# UNITED STATES PATENT AND TRADEMARK OFFICE

APPLICATION NO.	FILING DATE	FIRST NAMED INVENTOR	ATTORNEY DOCKET NO.	CONFIRMATION NO.
10/589,598	08/16/2006	John Henry Courtenay	HLBB-P01-002	9885

<b>Office Action Summary</b>	<b>Application No.</b> 10/589,598	<b>Applicant(s)</b> COURTENAY, JOHN HENRY	
	<b>Examiner</b> /Robert James Popovics/	<b>Art Unit</b> 1797

## **DETAILED ACTION**

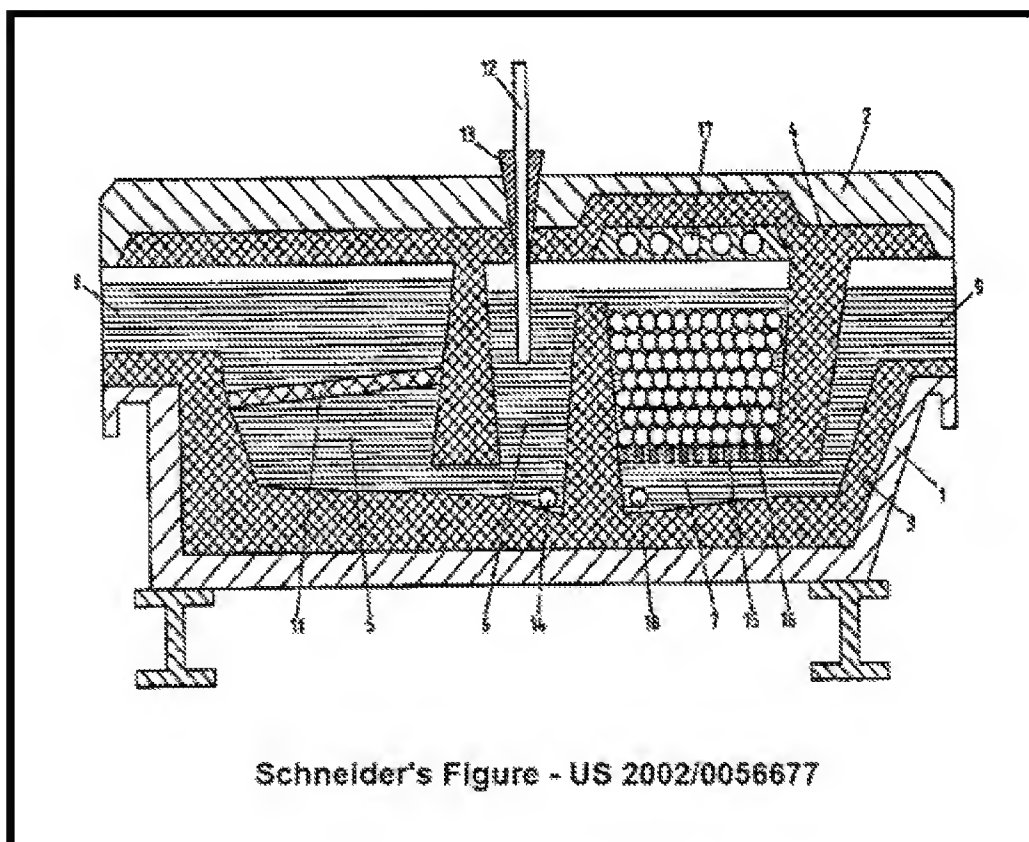
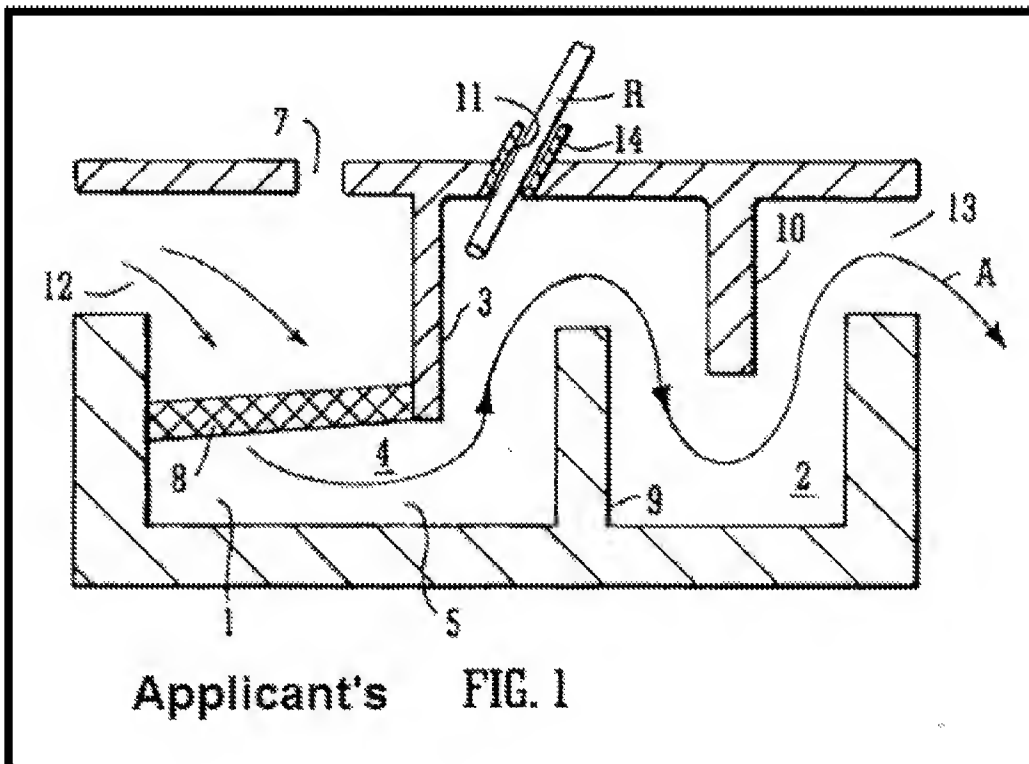
As clear from the comparative figures above, Applicant's structure is substantially similar to that of Schneider. The claims essentially differ from Schneider by specifying the addition a "cake formation agent." Enright (US 4,872,908 discloses the addition of a "cake formation agent" – see column 3, lines 1-67, especially, lines 33-38:

**4,872,908**

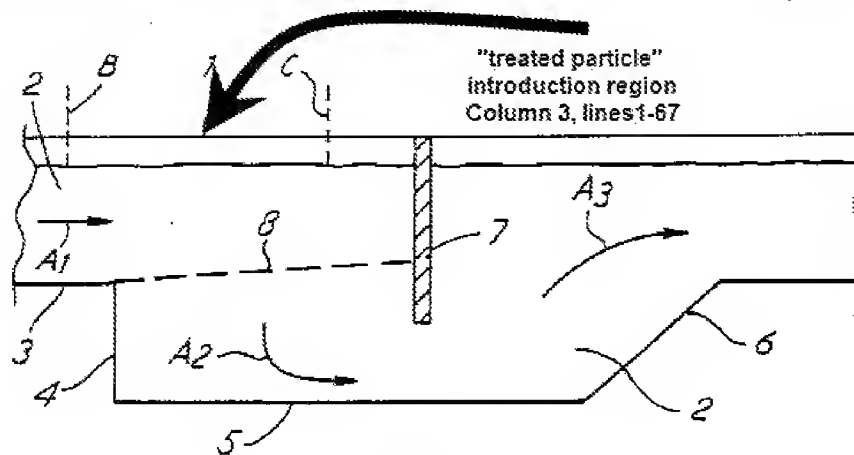
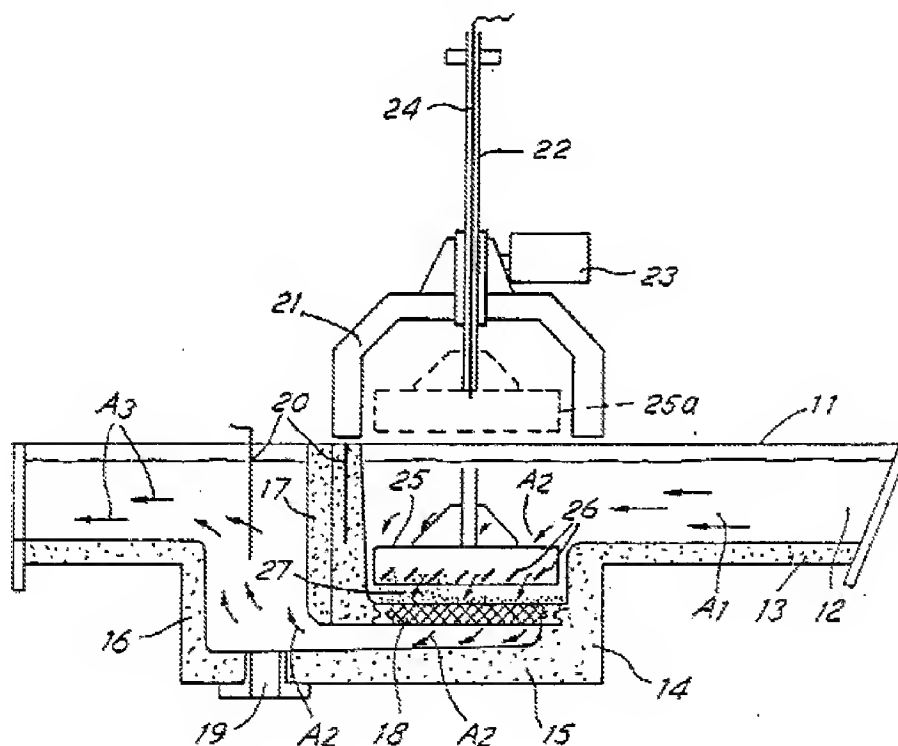
In view of the disclosure of Enright, it would have been obvious to one skilled in the art to employ a cake formation agent in the system of Schneider, in order to enhance filtration and improve the efficiency of the system.
